**REPORT TO THE SUBDIVISION AND  
DEVELOPMENT APPEAL BOARD**

| <b>DATE:</b> August 25, 2026                                                                                                                                                                                                                                                                                                | <b>APPEAL NO.:</b> SDAB2026-0125<br><b>FILE NO.:</b> DP2025-06578 |
| <b>FROM A DECISION OF THE DEVELOPMENT<br/>AUTHORITY where a</b><br><br><b>New: Rowhouse Building (1 building),<br/>Accessory Residential Building (garage and<br/>mobility storage), Secondary Suite (4 suites)</b><br><br><b>was approved at <u>10 Cheyenne Crescent NW</u><br/><u>(Bldg: 4 Cheyenne Crescent NW).</u></b> | <b>LAND USE DESIGNATION: R-CG</b><br><br><b>Discretionary</b>     |

1 GARAGE FLOOR PLAN  
1:48

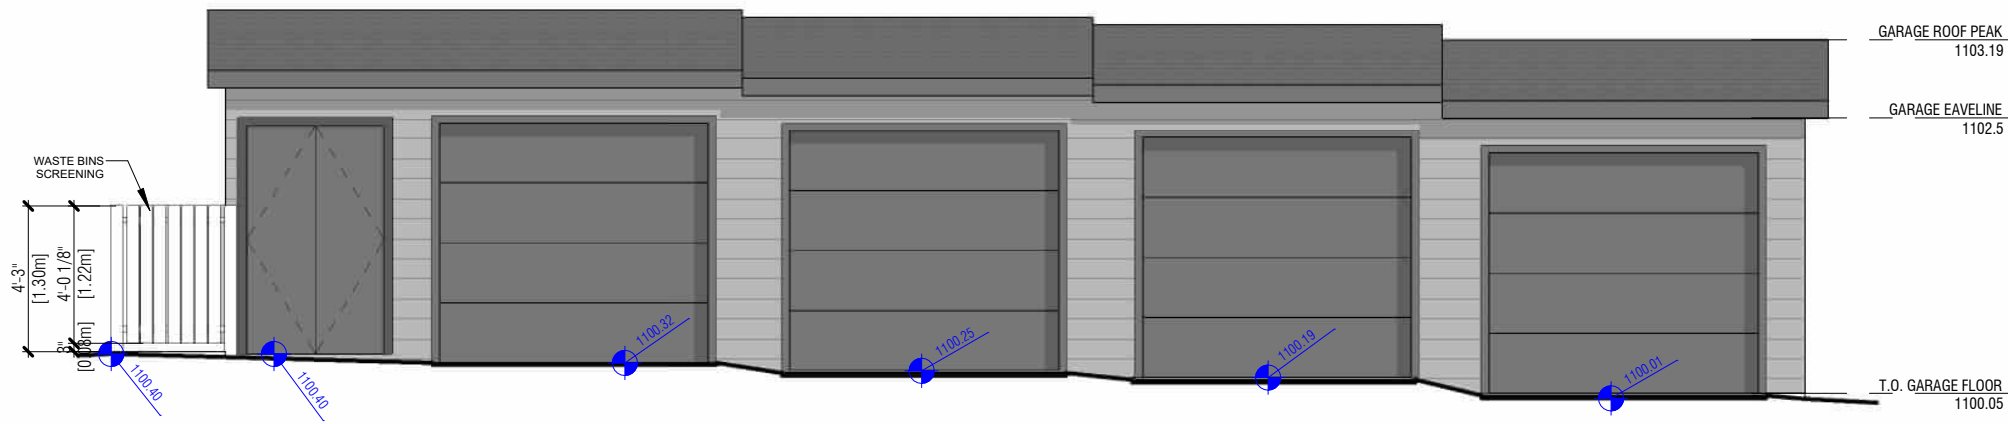
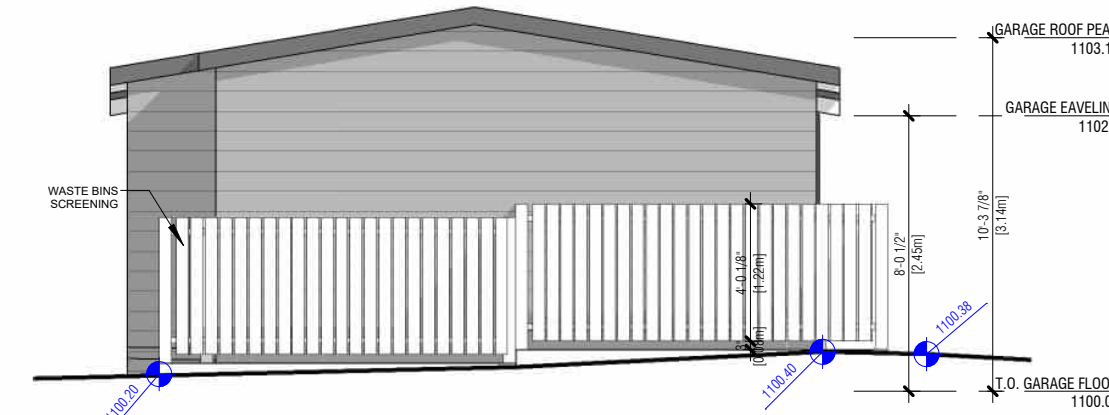
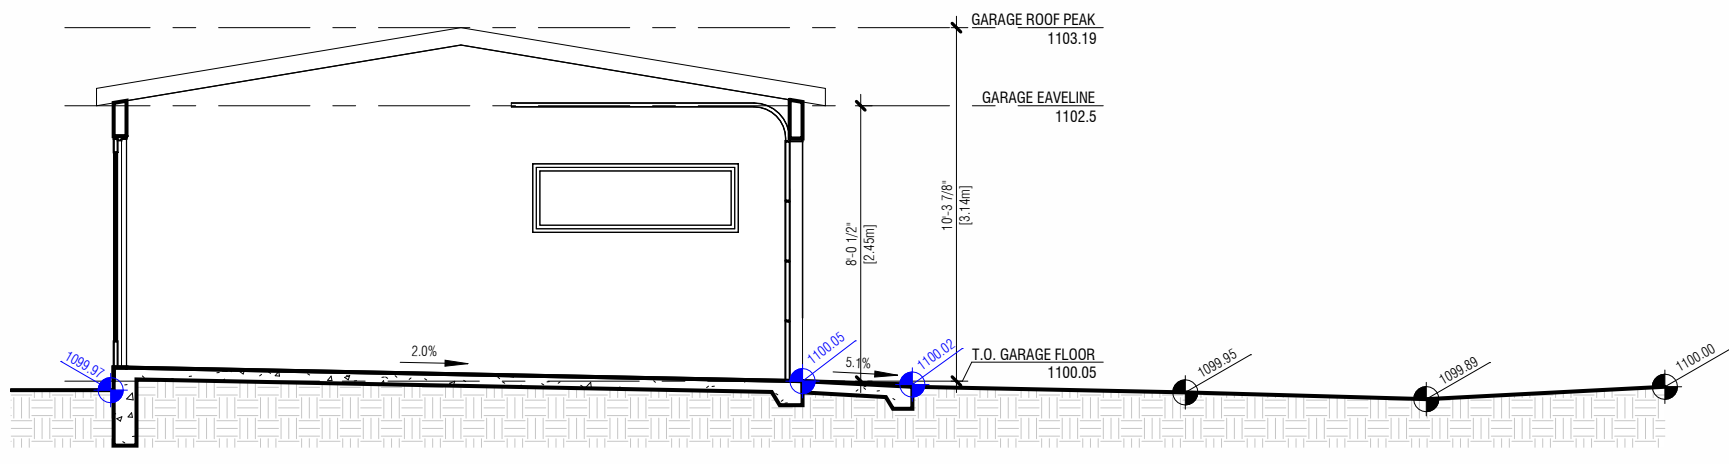
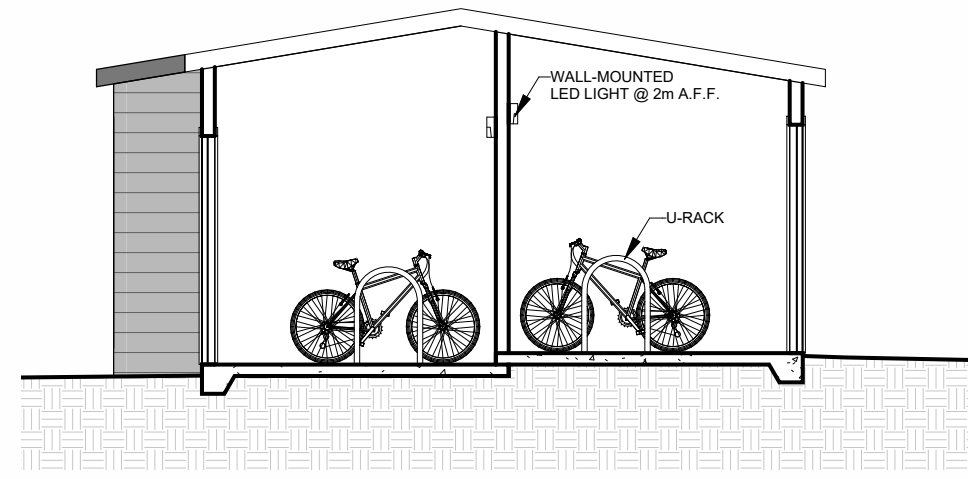
| Final Bylaw Relaxations                       |                                                                                                                                                                                                                                                             |                                                                                                                          |
|-----------------------------------------------|-------------------------------------------------------------------------------------------------------------------------------------------------------------------------------------------------------------------------------------------------------------|--------------------------------------------------------------------------------------------------------------------------|
| 345 Accessory Residential Building            | (6) The height of an Accessory Residential Building must not exceed:<br>(b) 3.0m at any eaveline, when measured from the finished floor of the building; or                                                                                                 | Plans indicate the interior wall height of the accessory residential building is 3.32m (+0.32m).<br><br><b>Resolved.</b> |
